Appeal Testimony re PDT 13-1

September 4, 2015

Re: City File No. PDT 13-1; Oakleigh PUD
Opposition to Hearings Official Decision

24 Ft. Streets Parking on one side only

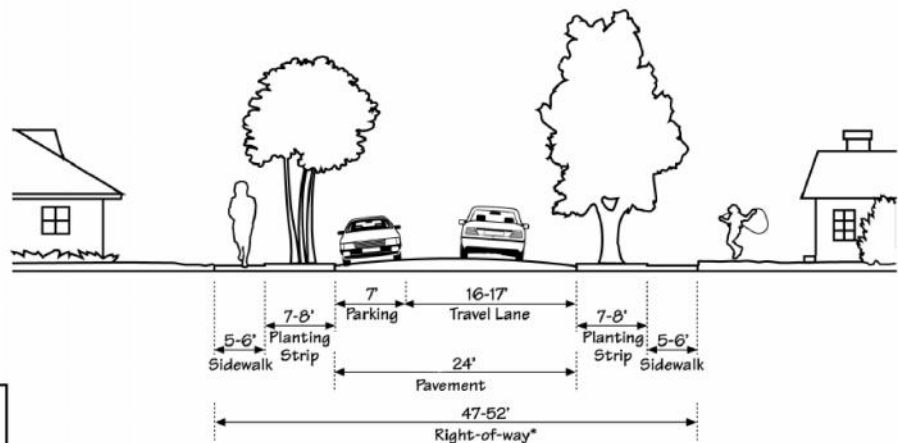
Note the 16'-17' Travel lane, with an additional 7' parking/pull-in area of pavement on one side. The required pavement for a queuing street is thus 23'-24' wide, much greater than Oakleigh Lane's pavement, particularly along the 250-foot "choke point."

A "queuing street" also does not force pedestrians to share the pavement with vehicular traffic; and, as the diagram above shows, the 47'-52' right-of-way provides room for separating pedestrian sidewalks from the roadway.

On the left is how a genuine queuing street would be configured and function (again, from page 18).
